BGA TECHNICAL NEWSHEET

TNS 3/4/85

PART 1. AIRWORTHINESS "AGGRO" - (Please add to the 1985 Green Pages)

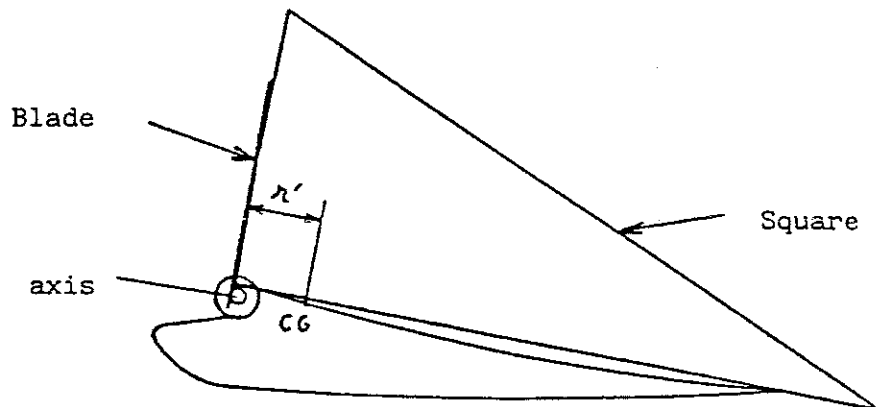
Weigh the cleaned ailerons, without their axis, with an exact balance. The weight has to be between 2,2 and 2,6 Kg. Find out the centre of gravity position of the aileron in the following way : vertical fixing of a needle. Put the aileron intrados on the needle and search for the centre of gravity position moving it until in balance. Check that the intrados is then correctly horizontal with the help of a spirit-level. Then adjust this laying point marking a small diameter circle around the needle. Often necessary to plug the front screw hole with cement because the centre of gravity can be located right there.

Exactly measure the distance between the aileron connection axis and its centre of gravity. For lack of a more accurate tool, put back the central hinge axis and make a blade strike on it upright to the intrados owing to a square lying on it.

Then measure the distance r' between that blade and the marked small circle centre which is the centre of gravity and subtract 3mm for the axis radius $\rightarrow r$. The maxi permissible miscalculation is 0,5mm. The product of the aileron weight (Kg) by the resulted length r (in cm) give the balance which must take place inside the definite limits as shown in Service Guide : 2,8 to 3,5 cm/Kg.

FIGURE 1

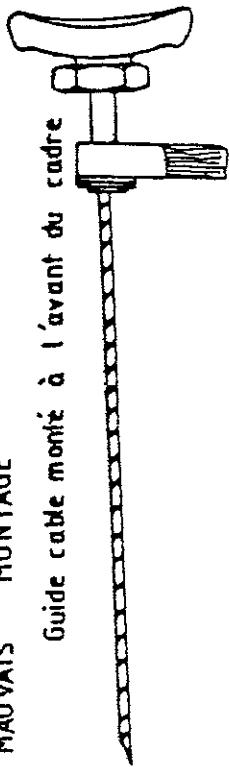
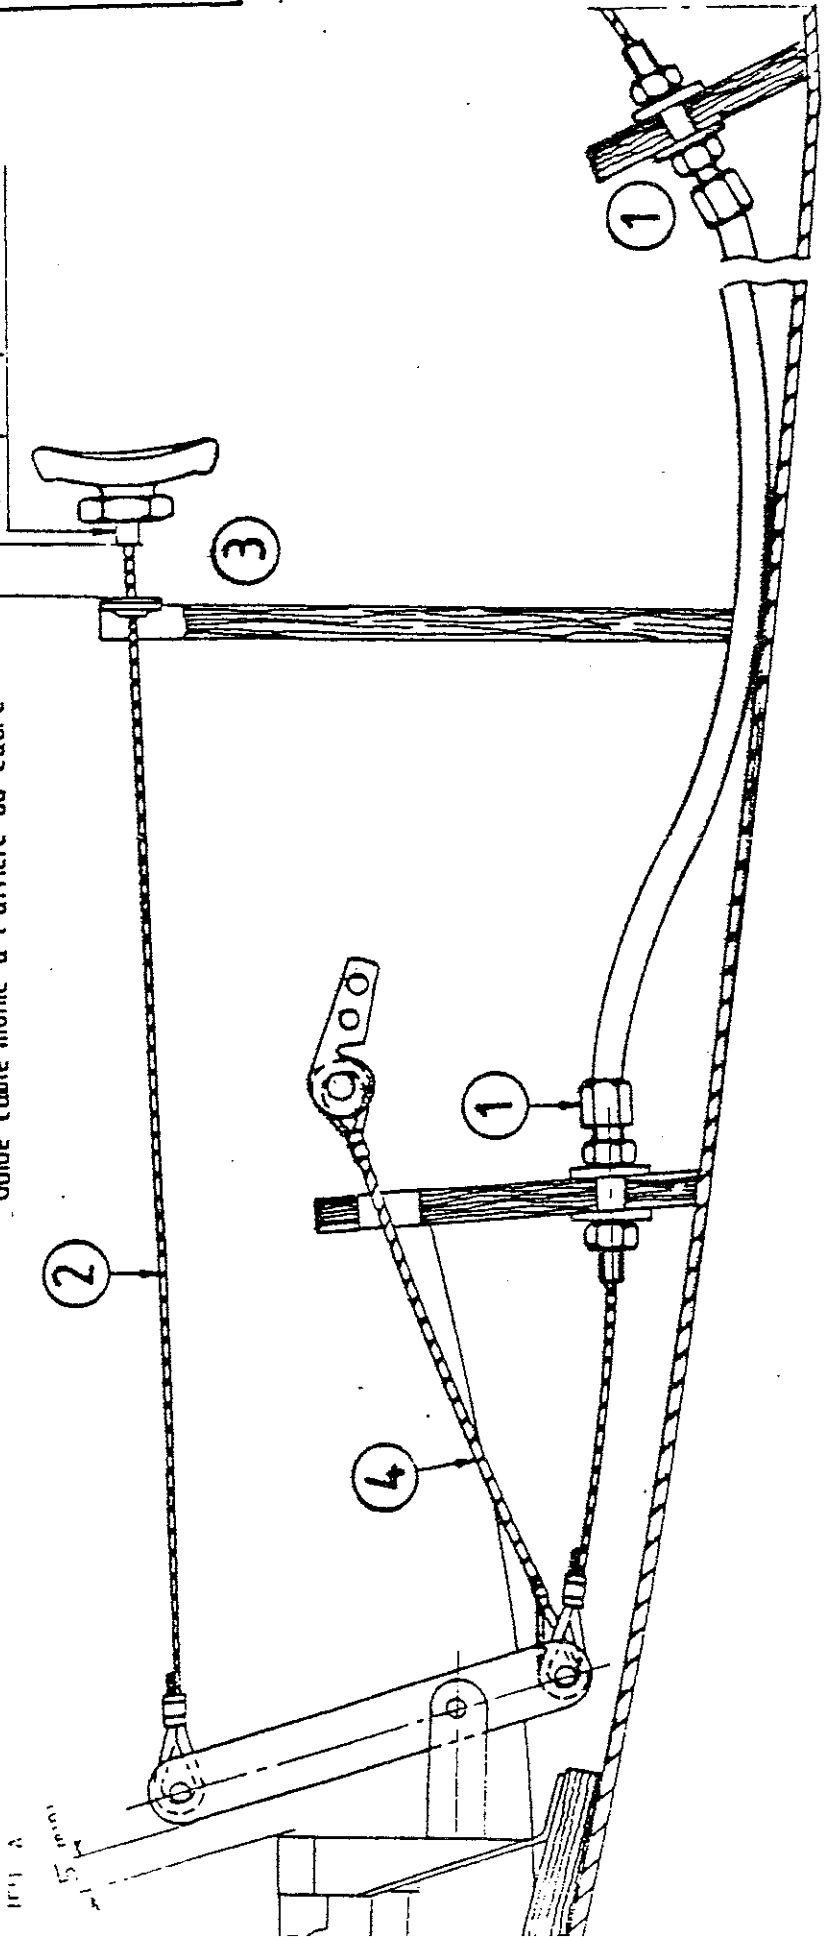
- 1 - Check whether the cable guiding fittings are mounted in front of the bulkhead (fig.1) or rear of it (fig.2)
- 2 - If the fittings are mounted in front of the bulkhead, they must be remounted to the rear.
- 3 - Check whether sufficient neutral travel is left as indicated in figure 2.

3.11) On gliders with a rear hook only, screw the adjusted bits (rep. 1 fig.2)

3.12) On gliders with a front hook only, replace the cable (rep. 4 fig.2)

3.13) On gliders with front and rear hooks, replace the cable (rep.4 fig.2) if this one shortens the neutral travel and play on the adjusted bits so that the stress is identical on the 2 hooks so that they release together.

3.21) On the gliders with rear hook only and with a plastic tube between the release cable fitting and the cable guide (rep. 3 fig. 2) to ajust it, shorten the plastic tube and/or screw the adjusted bits (rep. 1 fig.2)

If no tube (rep.3 fig.2), screw the adjusted bits rep.1 fig.2 . If no back lash, replace the cable control (rep.2 fig.2)

Sketch 1

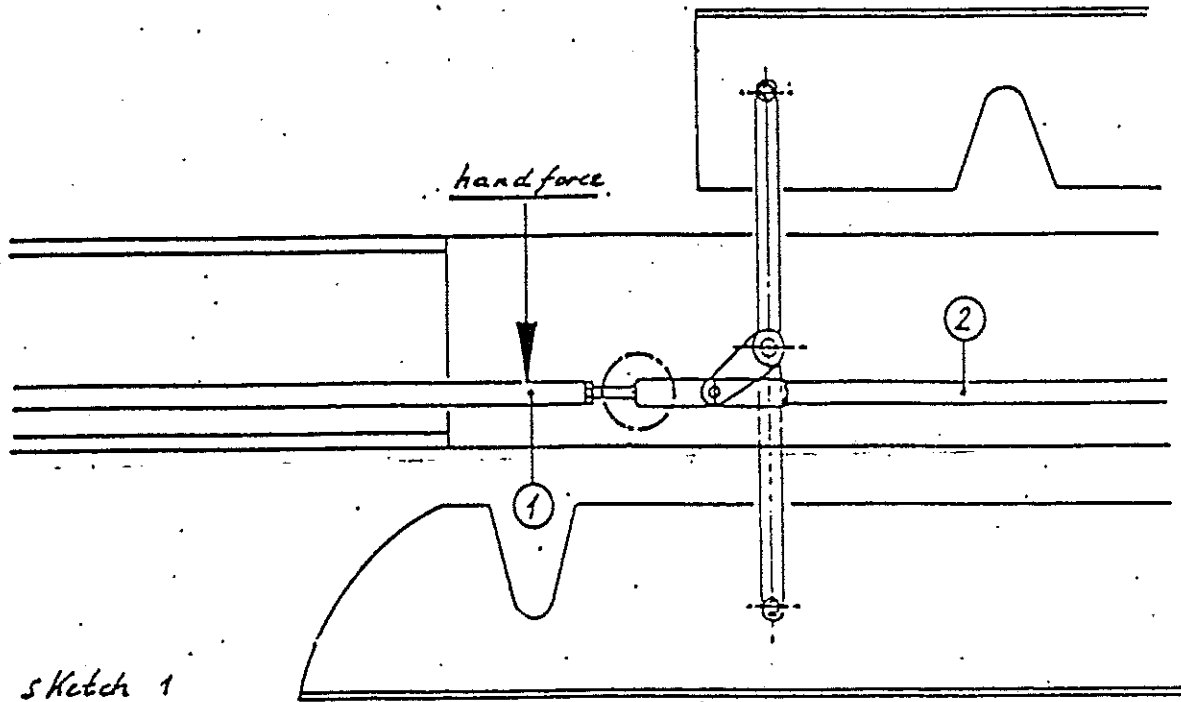
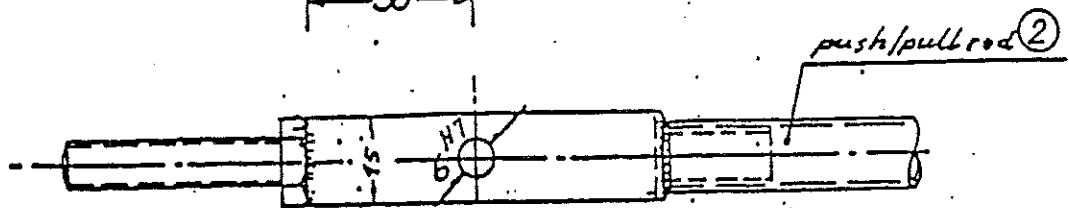
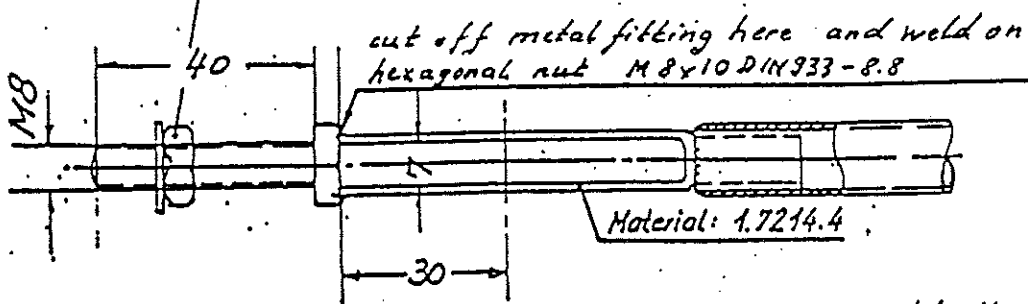
- Note:
These actions do not apply for sailplanes on which the 6 mm threaded bolt has already been replaced by an 8 mm bolt.
2. To remove the connecting rod ② between the airbrake bellcranks first turn out the push/pull tube ① at the root rib, then undo the split pins at the airbrake bellcranks.

3. a) Modify the connecting rod ② according to sketch 2
or
b) obtain a replacement rod ② according to
- | Drawing No. | Nomenclature |

- from the manufacturer.
4. Tap a 8 mm (0.31 in.) thread into the threaded end of the push/pull rod ① .
5. Reinstall modified connecting rod ② (after accomplishment of action 3). Reinstall push/pull rod ① (after accomplishment of action 4).

BRAKE ROD END FAILURE

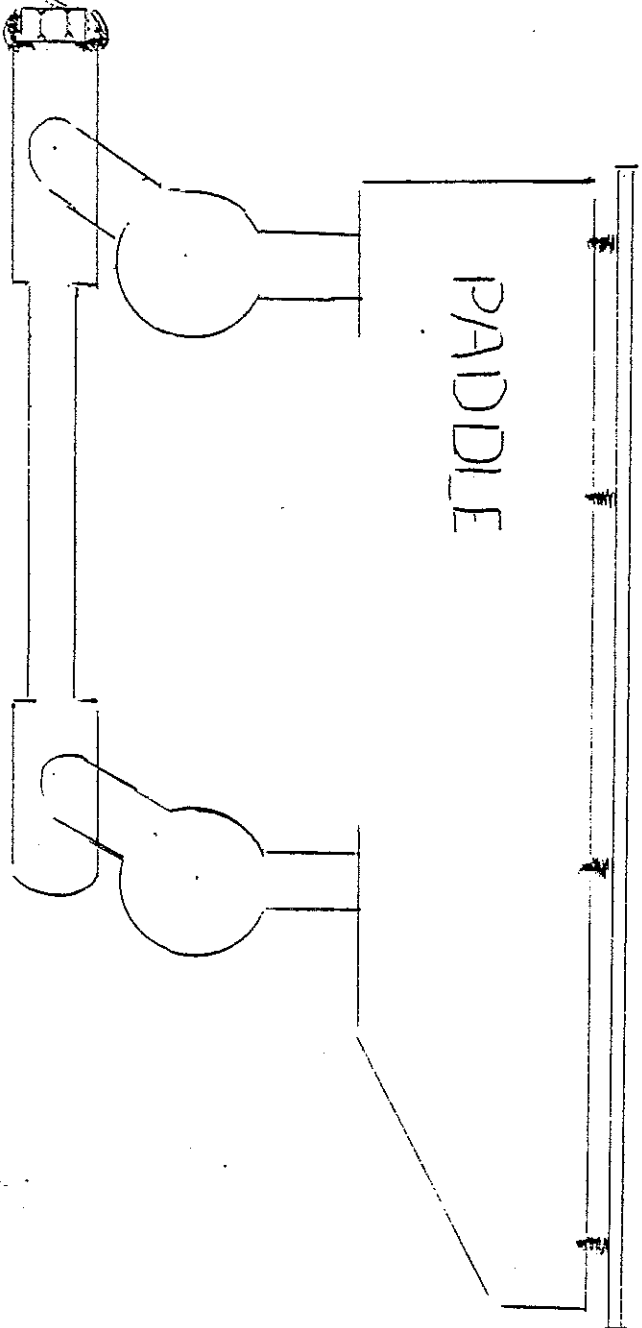
- 1.10 OPEN CIRRUS - Speed-brake Rod Failure. Tech Note 265-8 amplifies the failure reported in TNS 1/85 (copy herewith).
